CITY OF AURORA
BUILDING DIVISION
APPROVED AS NOTED
DATE 10/8/09

MEDICAL CENTER OF AURORA

FOURTH FLOOR RENOVATION

FOUR EAST REFLECTED CEILING PLAN

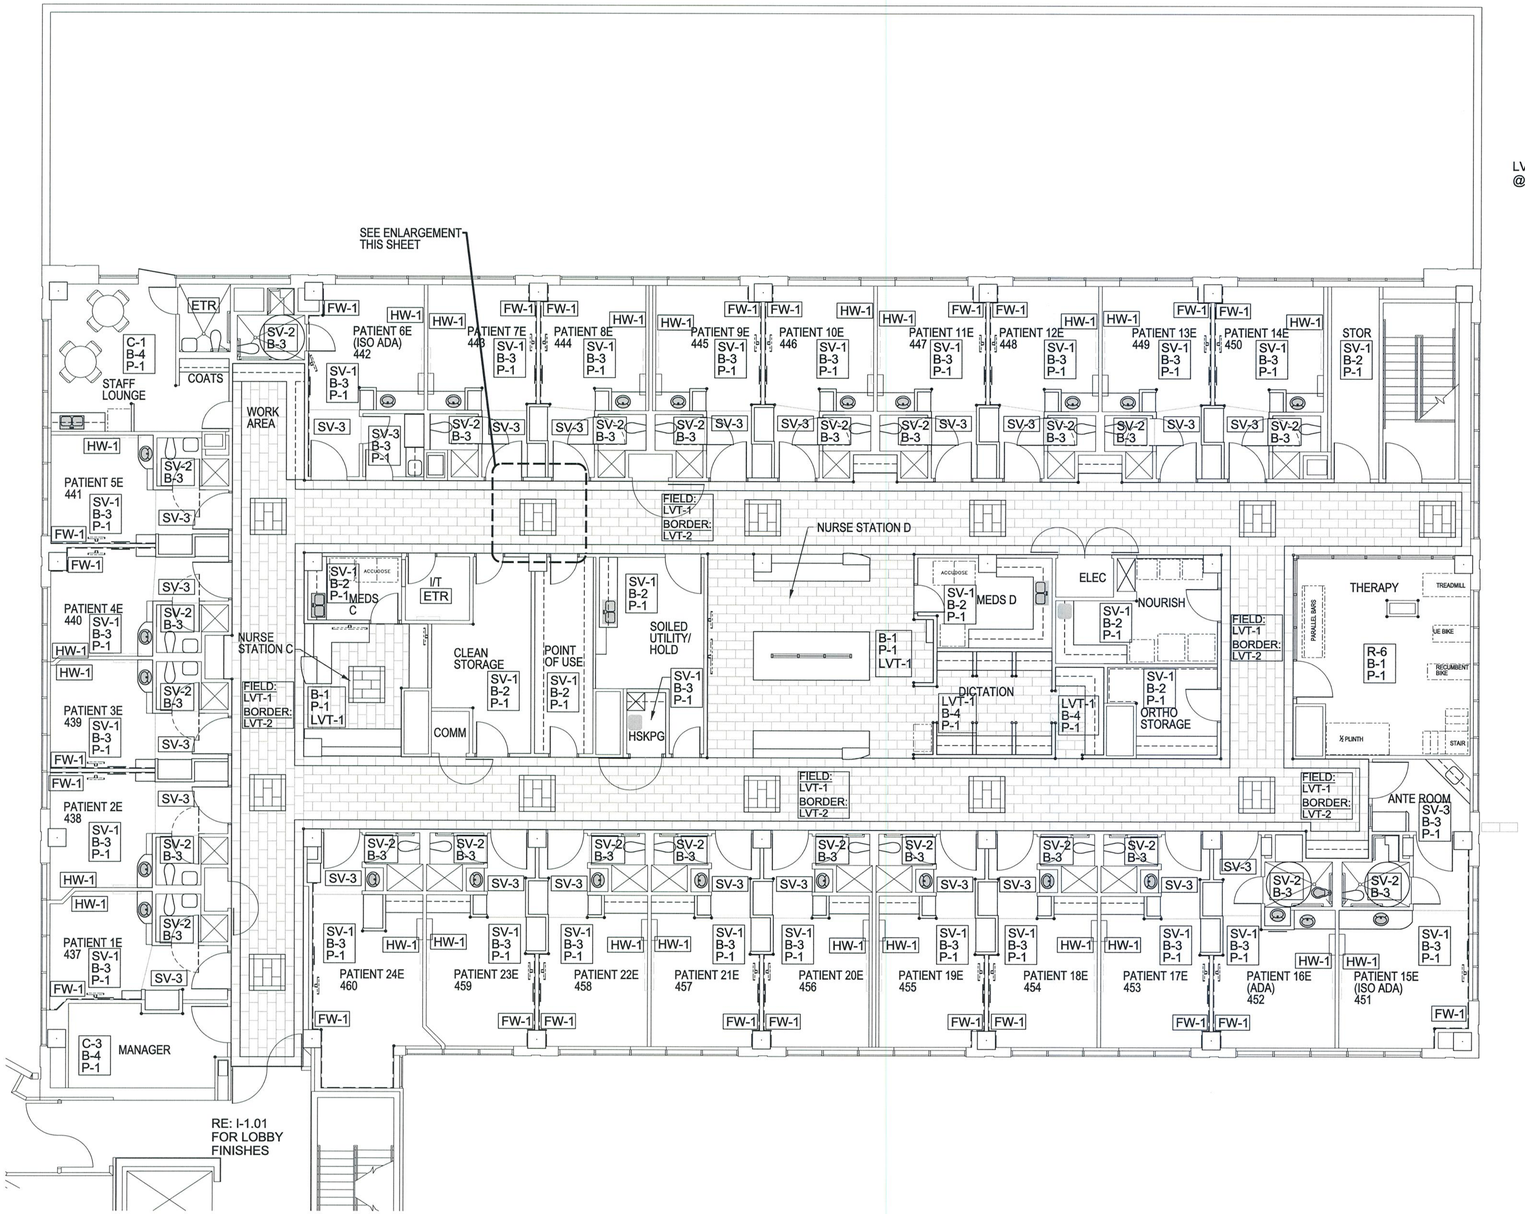
1. The Reflected Ceiling Plan has been updated with dimensions and radii for the soffits, and is being issued here as Addendum #7.
2. The soffit at the East Wing Nurse Station C has been revised so that the soffited area is smaller.

1 REVISED FINISH PLAN - EAST
SCALE: 1/8" = 1'-0"

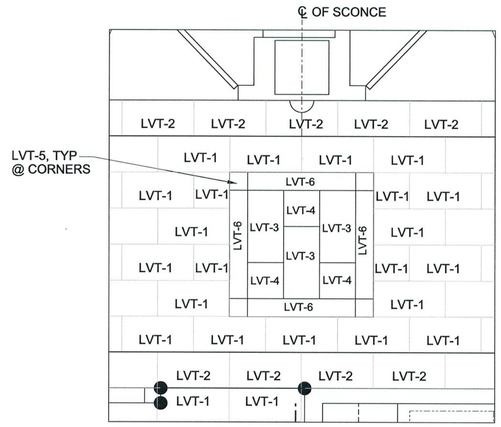
1. **Revised Finish Plan Attached**. Materials and Quanties have changed across entire scope of project. Please reprice finishes package. This will affect some current outstanding submittals.

5. Clarification on Finish Plans: every room is to be painted P-1 (unless specifically designated a different color). Some rooms are shown with no paint designation, but are meant to be included in the scope of painting work.
